**Subject: Site Plan Response to Second Round of Comments
 Site Plan Development Project Application (SP26-000033)
 Messer LLC Air Separation Unit Facility
 1096 Boatcallie Rd., Bryan, TX 77808**

Messer LLC (Messer) received comments, dated August 11, 2026, from the City of Bryan regarding the Site Plan submitted in support of a Site Plan Development Project Application for development of a new Messer Air Separation Unit (ASU) Facility located at 1096 Boatcallie Rd, Bryan, TX 77808.

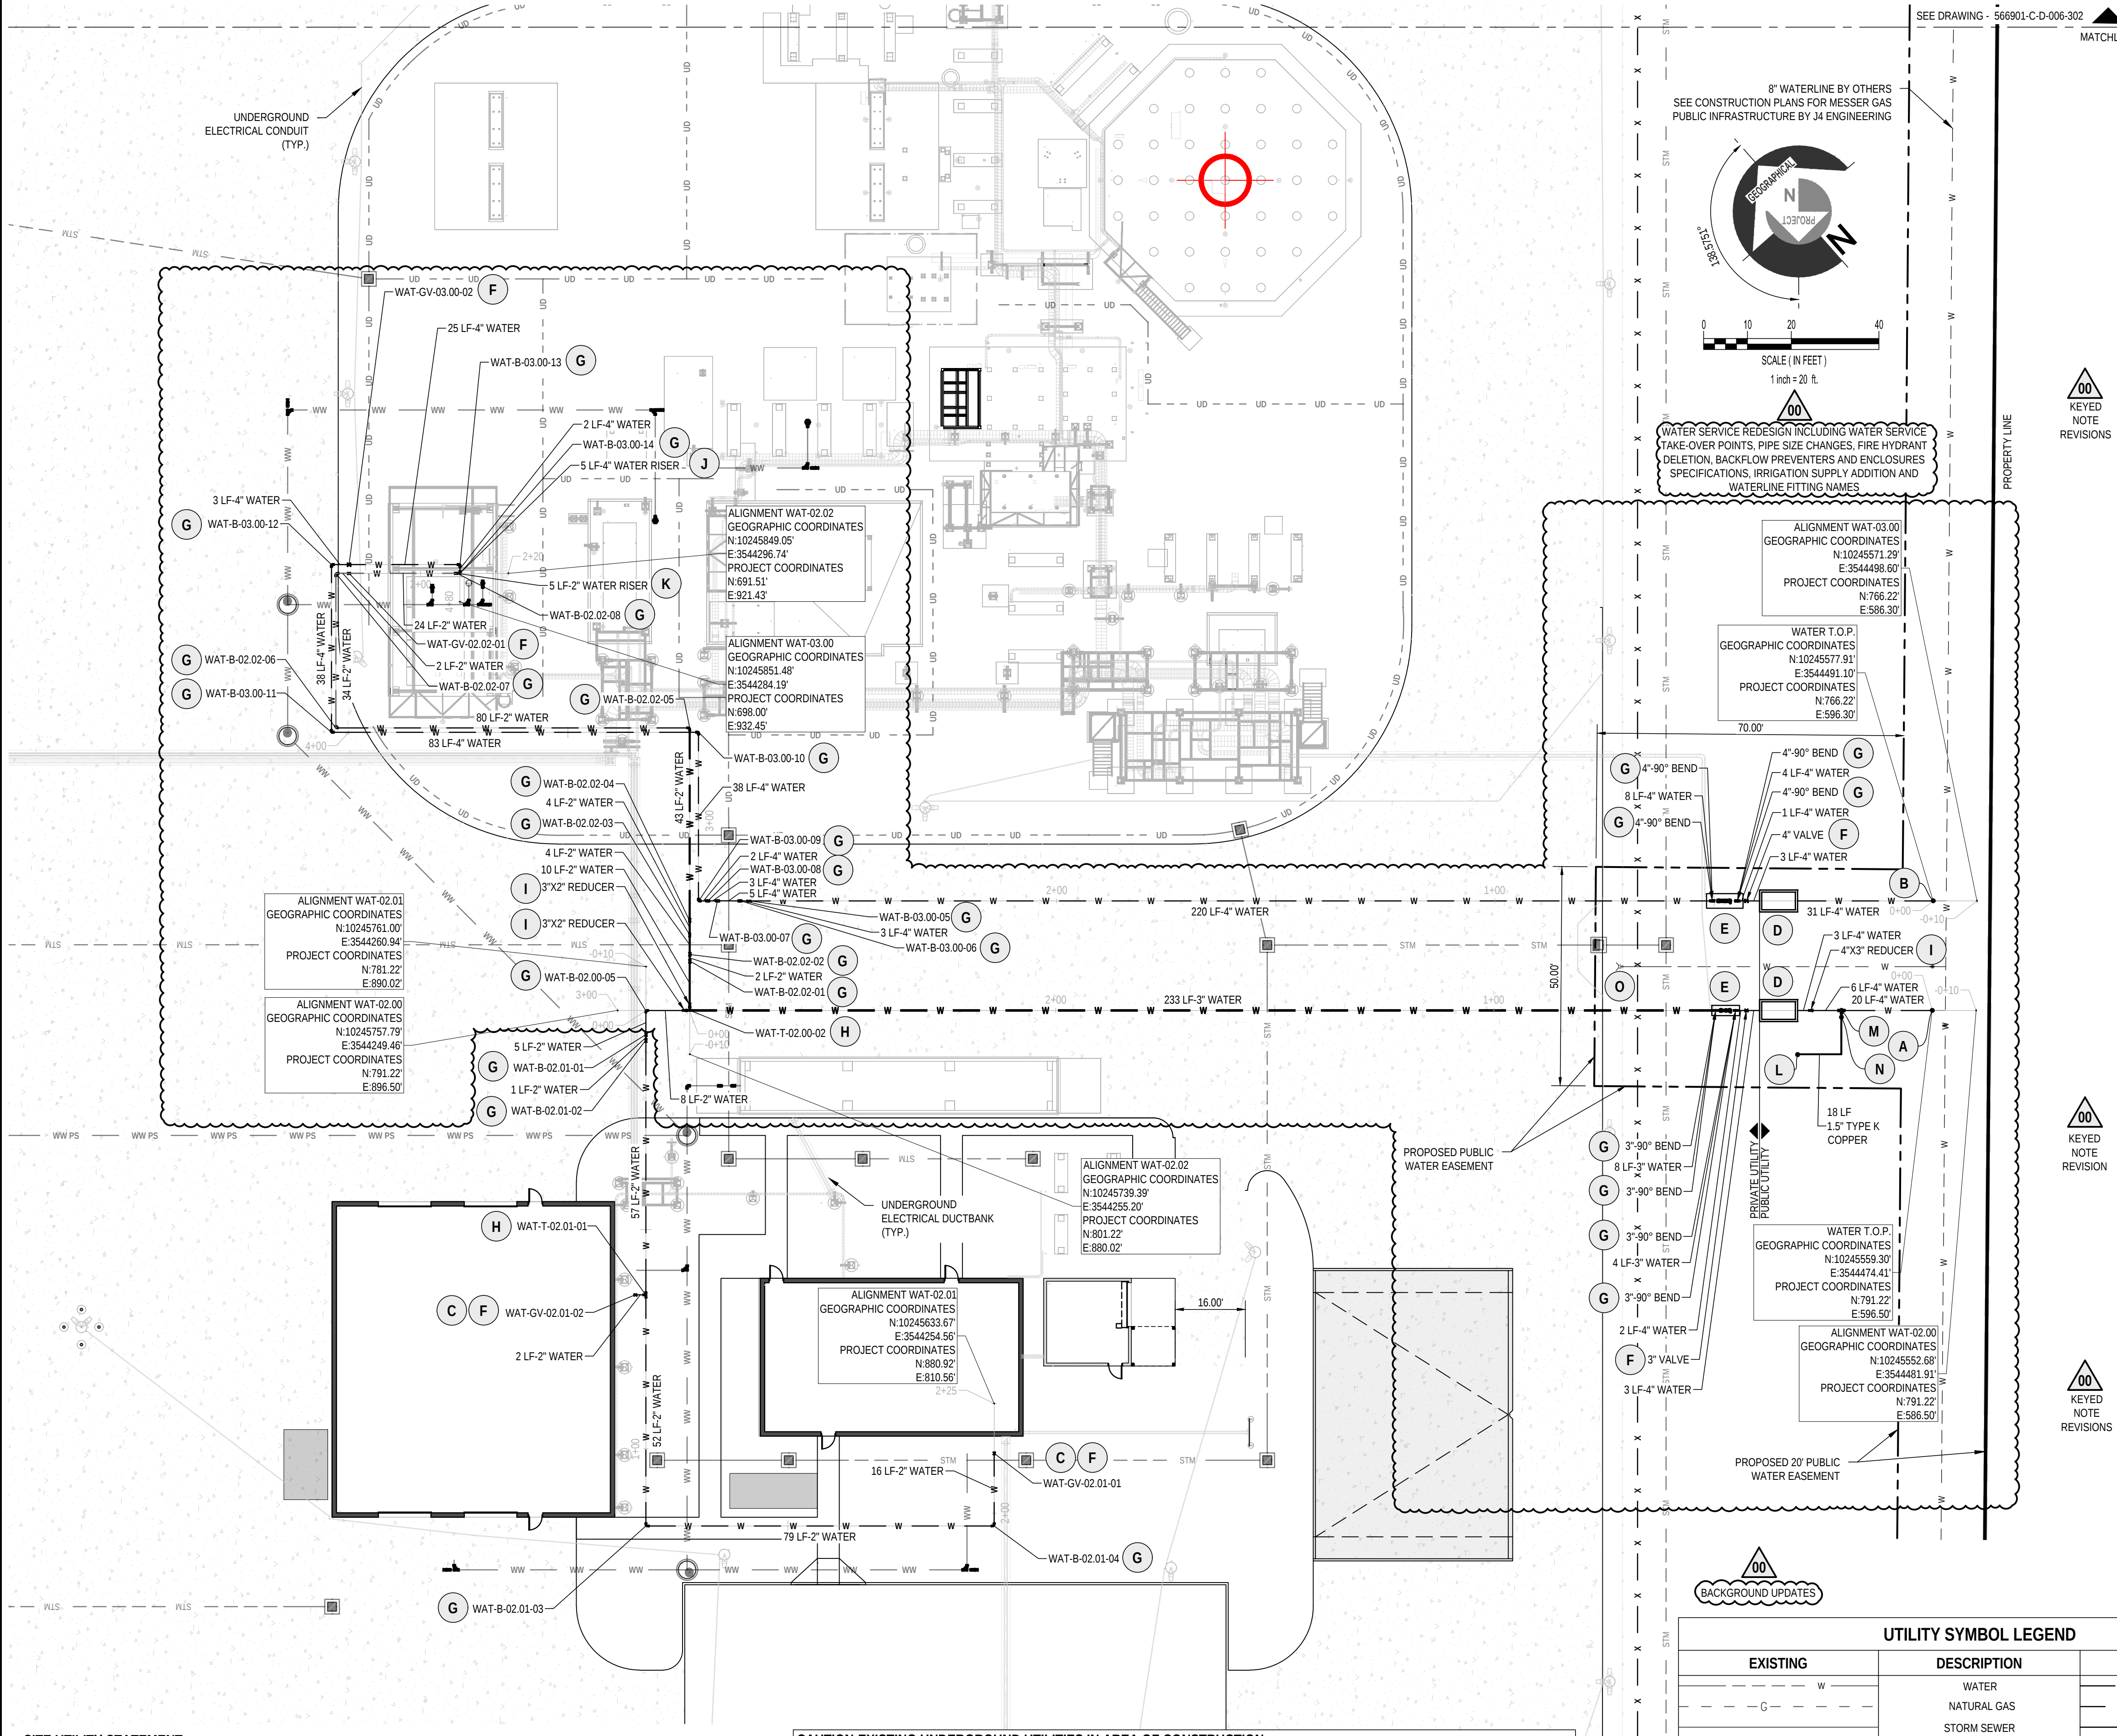
- ❑ Please contact Water Services to discuss the water meters and the location of the fire hydrant on the private side line. Water Services prefers the fire hydrant to not be located on the domestic meter.

A meeting was held and following correspondence/discussion took place to discuss the water meters and the location of the fire hydrant. The potable water service was modified as requested by the City to relocate the private hydrant off the potable water service as a public hydrant on a separate public service line at an on-site location accepted by the City. The private potable water line size was reduced. Two, 4-inch service lines are extended from the public water main. A RPZ type backflow preventer and heated enclosure has been selected for each the potable and process water services. An irrigation feed was added off the 4" potable water fed prior to the potable water meter. The design for the irrigation meter and backflow preventer is anticipated to be provided with the landscape plans.

Attached are the related updated water utility plans, including the index sheet 566901-C-D-001-001-00 as well as sheets 566901-C-D-006-301-00 and 566901-C-D-006-302-00.
